# Rezoning Transportation Analysis

Petition Number: #2022-109

Date	Description
11-28-22	First Review (IW)
12-21-22	Second Review (IW)
01-25-23	Third Review (TM)

Reference (CLDSM standard detail U-02) for residential medium street typical.

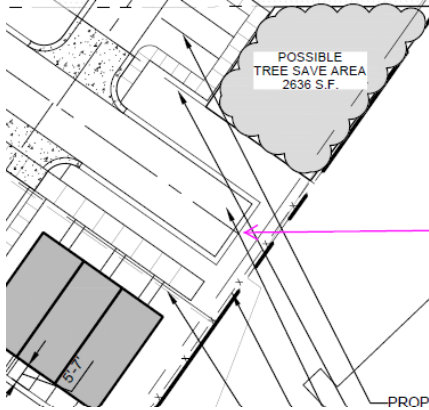
4. The proposed dwelling units exceeds 12 per acre. Per Chapter 20 Subdivision ordinance, site plan and conditional note(s) revisions are needed to commit to construct an 8-foot planting strip, and 8-foot sidewalk along all public roads. The wider sidewalk also meets the Charlotte WALKS Policy.

**Clarifying Comment 12-21-22:** Petitioner should add conditional note stating commitment of 8' planting strip and 8' sidewalk along both sides of all public roads. Reference (CLDSM standard detail U-02) for residential medium street typical section. Potential environmental conflicts to be coordinated during permitting if full section cannot be achieved.
